Lal Lal Wind Farm Layout Amendment Assessment

Report for
The Sovereign Hills Museum Association
c/- Kellehers Australia
497 Swan Street
Burnley VIC 3121

October 2016

Reference: P1646-C001-002

Figure 3-6: View from near the window of H18aa towards nearest turbine ESWT02 location

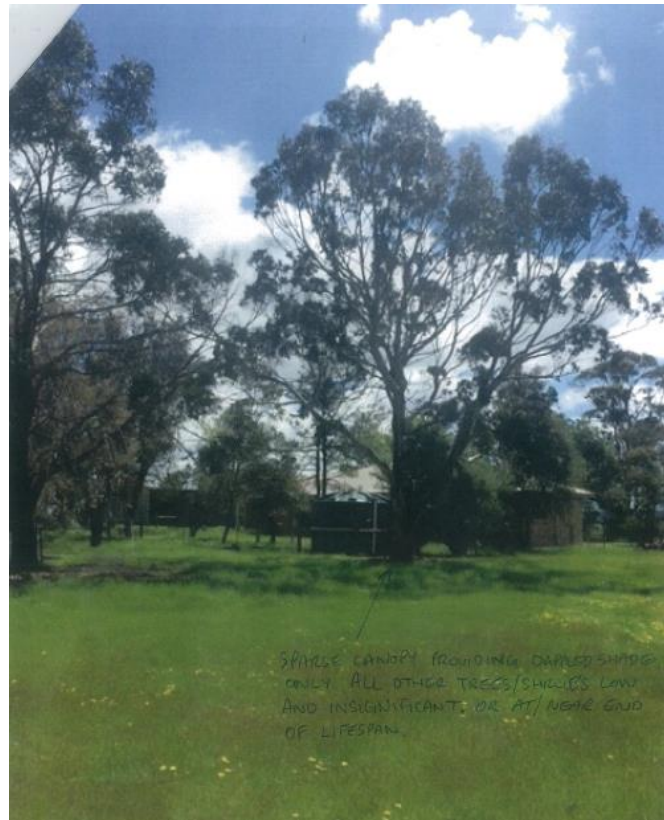
Given that the canopy of the largest tree in this direction is sparse (semi-transparent) rather than dense (fully opaque), it is possible that shadow flicker from a turbine behind the tree will reach the window of the property despite the partial screening provided by the tree. Enhar has not prepared a visual simulation of turbine appearance from this location, however it is conservatively assumed the turbine is visible.

In line with the allowable mitigations in Table E-3 of the Draft Australian Wind Farm Guidelines, it can therefore be assumed that worst case astronomical condition shadow flicker hours are not reduced through the presence of trees in this location since they are not expected to completely block the view of the turbine.

Figure 3-7: Shadow flicker contours (hours/year) for turbines ESWT 02 and 01, with property H18aa

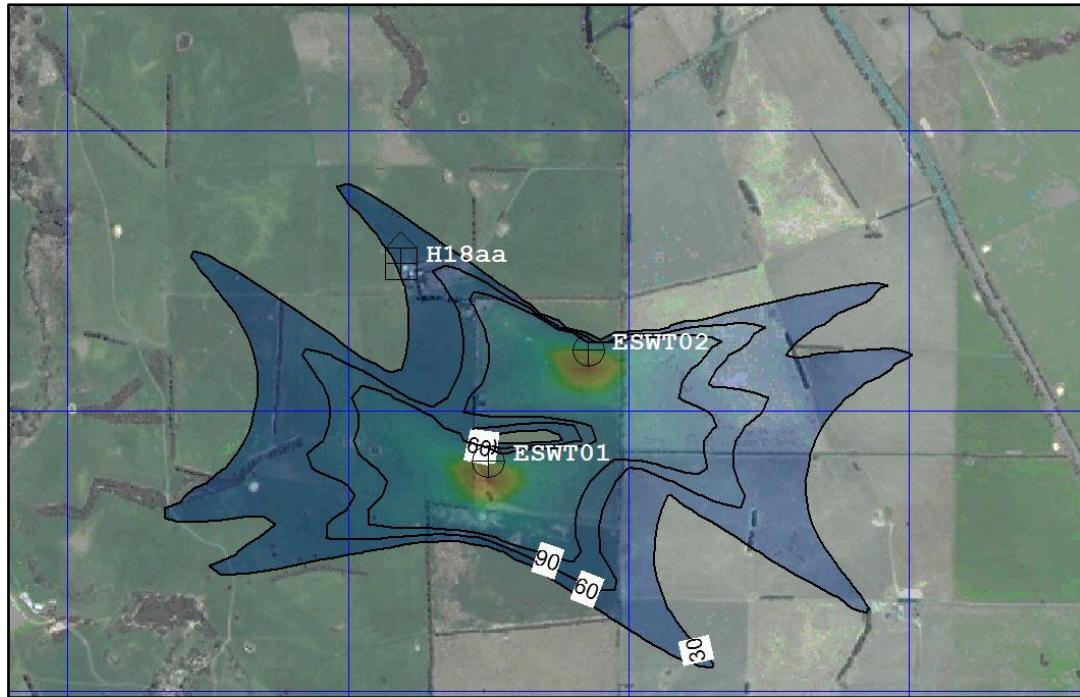
The location ESWT02 is one of the two locations which Sovereign Hill is seeking to relocate, such as to area C in the Narmbool plan. Relocating the turbine to area C would remove all shadow flicker at H18aa. Alternatively, the turbine could be moved further south within the current land parcel whilst still being adequately spaced relative to neighbouring turbines for wake loss purposes. The image below shows the calculated shadow flicker contours overlaid on georeferenced imagery from Google Earth.

Figure 3-8: Shadow flicker times at property H18aa due to ESWT02

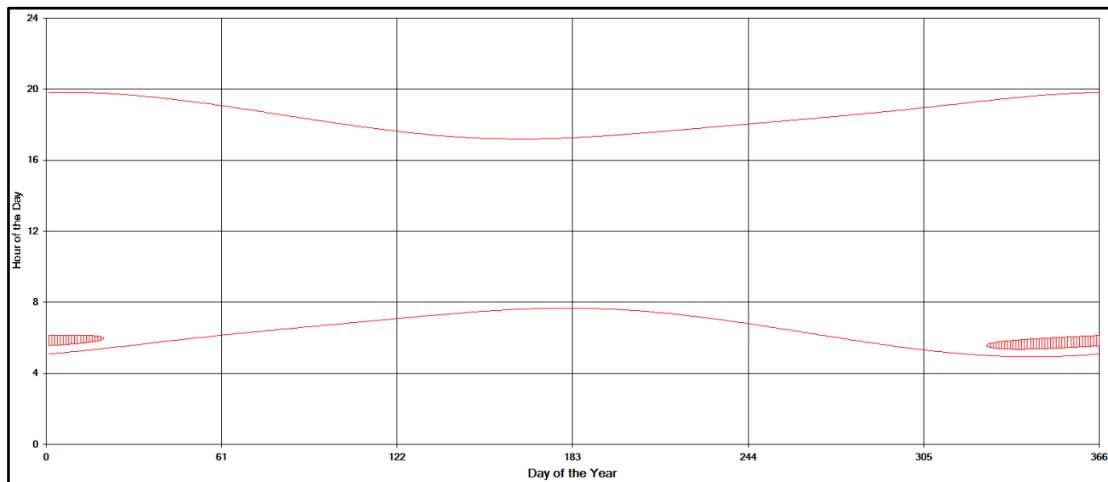
The following graph shows the times of day and year during which property H18aa is affected by shadow flicker from turbine ESWT02 after WWE’s amendment. The y-axis represents hour of day while the x-axis represents day of year. The red shaded area in the graph therefore suggests that shadow flicker occurs at this property from approximately late October to late January in the early hours of the morning, around 5:30am to 6:00am. The south and east windows are affected in roughly equal measure. Results are tabulated below for the affected windows of the house.

Window	Days Per Year	Max Hours Per Day	Mean Hours Per Day	Total Hours
East	66	0.65	0.5	33.1
South	66	0.65	0.5	33.0

Figure 3-9: Suggested amendment for reducing shadow flicker hours at property H18aa to below 30 hours due to turbine ESWT02.

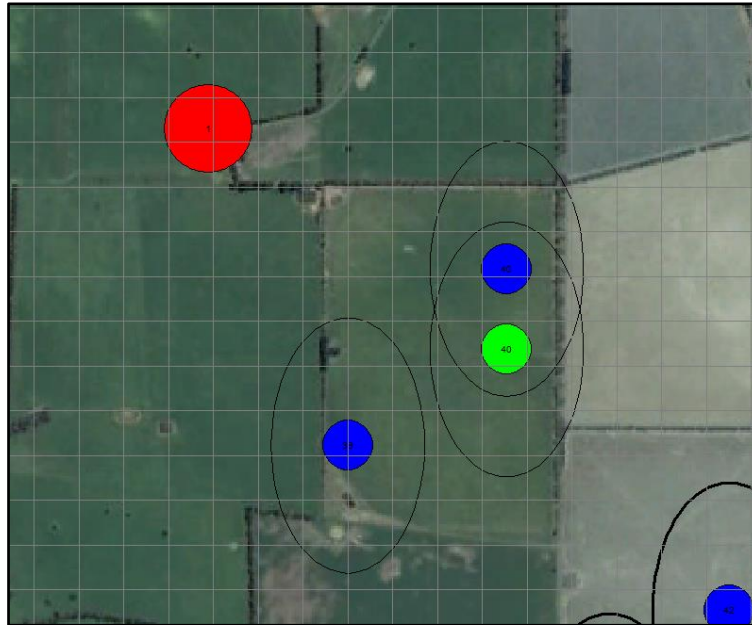
Following from this result, Enhar found that moving ESWT02 further directly south by ~180m would reduce the number of shadow flicker hours for the year to below 30 hours at property H18aa, according to the WindFarm model used. This shift is illustrated in the image below with the green marker representing the suggested southward relocation. With these new coordinates of 233855 E, 5818037 N, ESWT02 appears still within the apparent project boundary, with a comfortable separation distance from the nearest turbine, ESWT01, along with no significant change in overall energy yield for the site. Enhar chose an elliptical spacing buffer of 5 x 3 rotor diameters for the turbine, based on the assumed prevailing wind direction.

Easting (m)	Northing (m)
Property H18aa	233189	5818529
ESWT02 WWE amendment	233855	5818217
ESWT02 relocated by Enhar for shadow flicker mitigation	233855	5818037

Window	Days Per Year	Max Hours Per Day	Mean Hours Per Day	Total Hours
East	60	0.60	0.5	29.8
South	60	0.60	0.5	29.8

Appendix 1 – Narmbool Plan showing alternative turbine positions

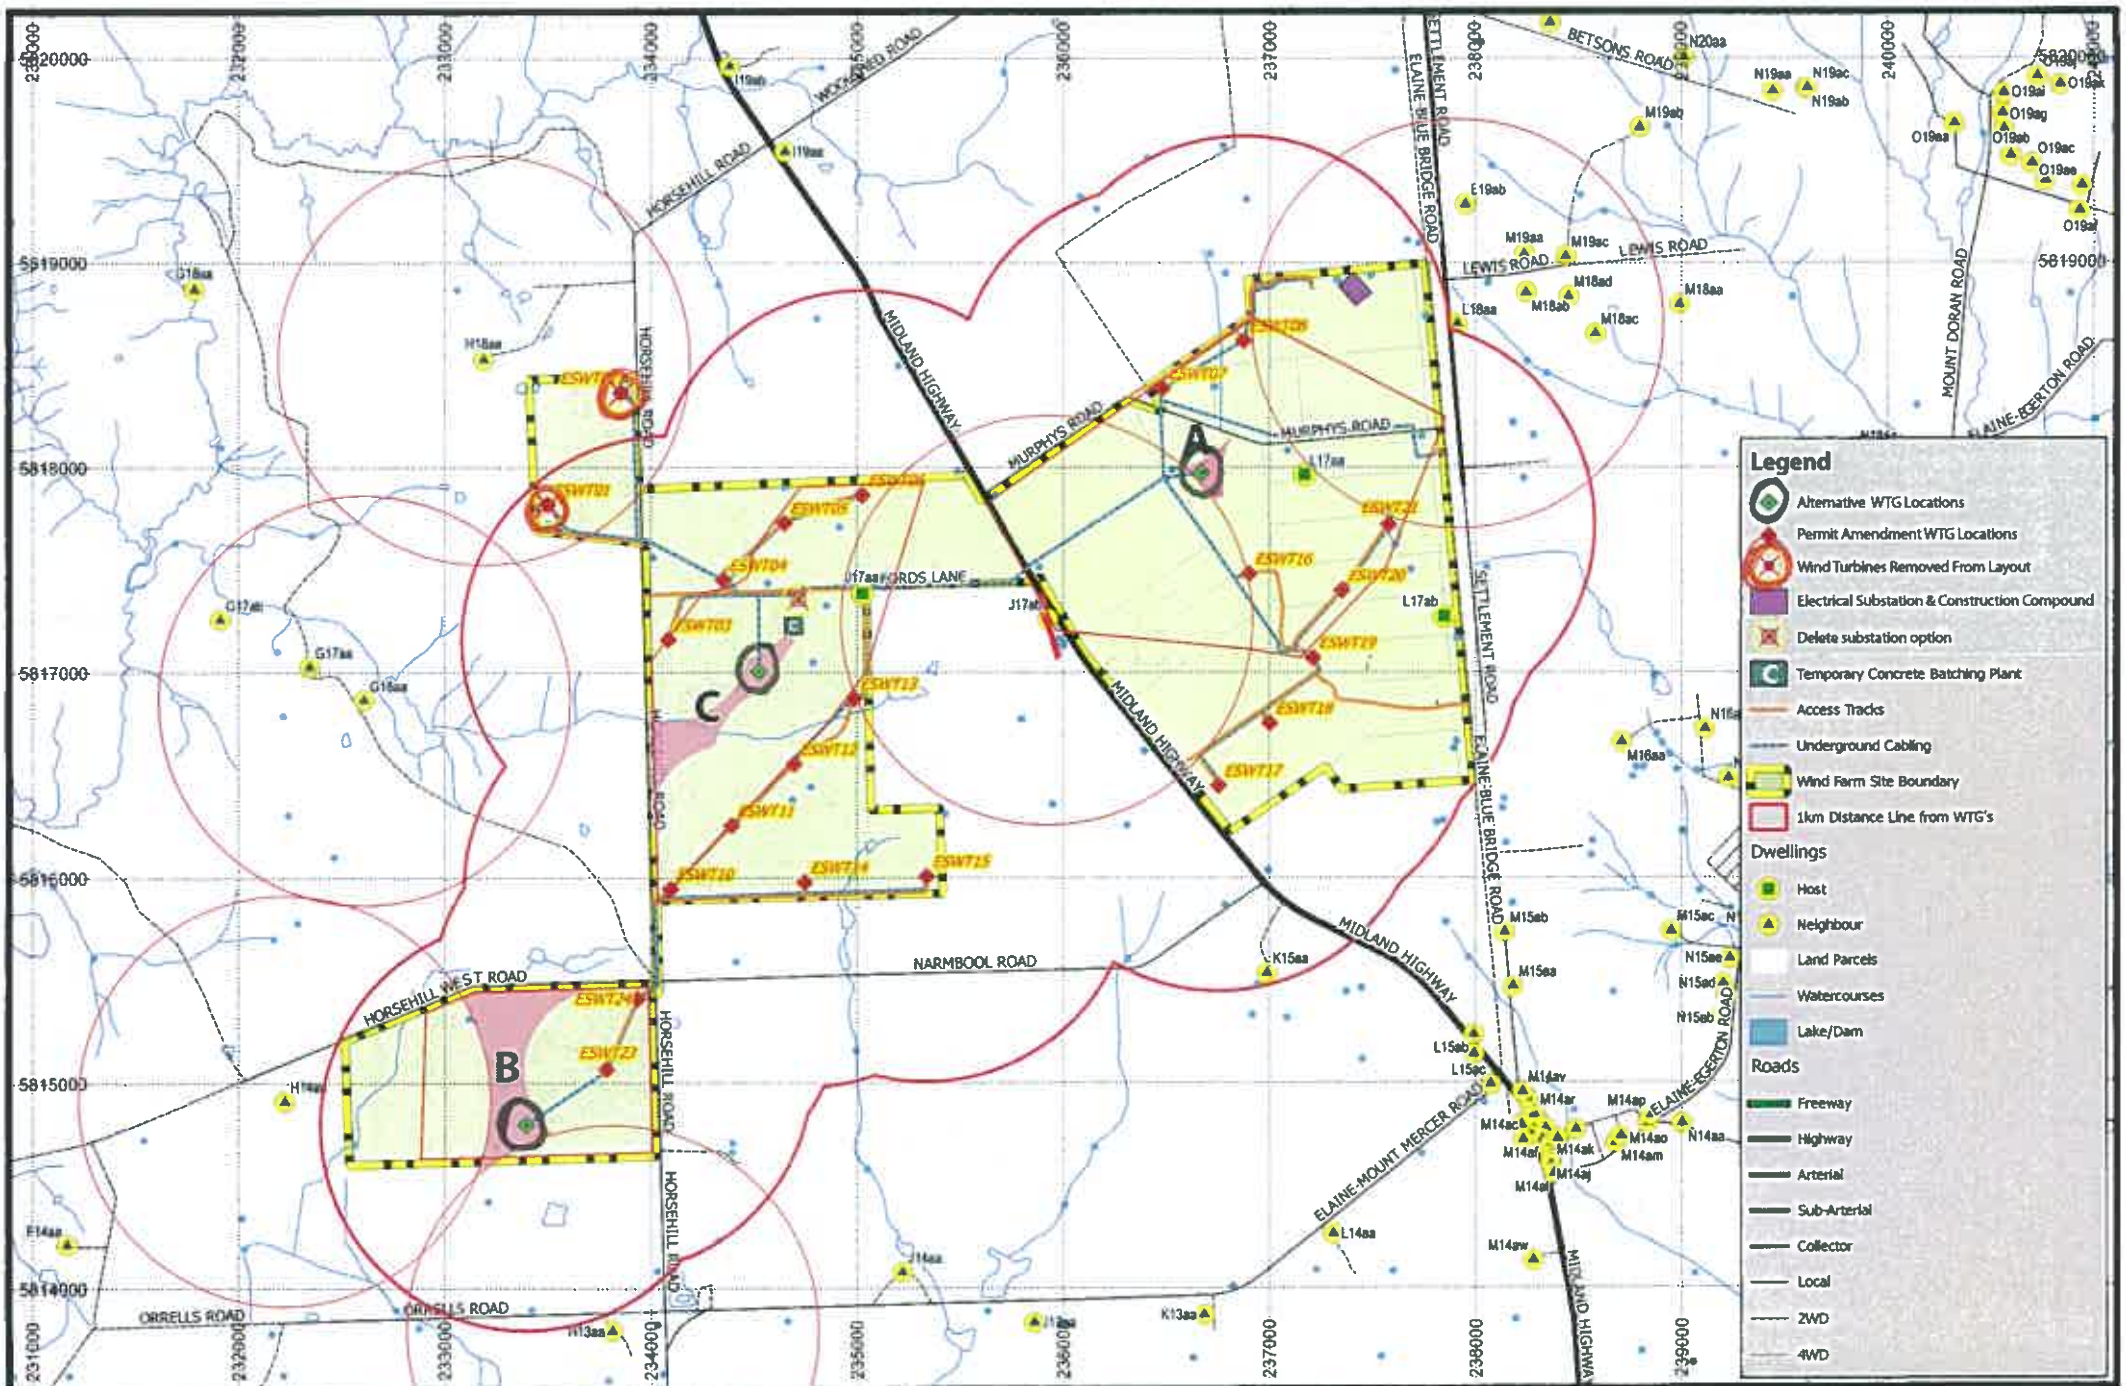
Three areas for alternative turbine locations were identified in the 'Narmbool Plan' by Sovereign Hill as A (north-east), B (south-west) and C (roughly central). This map is included below in Appendix 1. Enhar used a georeferenced image of this map to place point locations representing the relocated turbines in a wind flow model. Subsequent correspondence from Kellehers to Enhar indicated that a meeting between WWE and Sovereign Hill occurred at which WWE advised areas A and B would not be feasible for additional turbines due to proximity to other dwellings and other objections. Enhar has therefore placed additional focus on area C, analysing a scenario where both turbines are relocated to this vicinity.
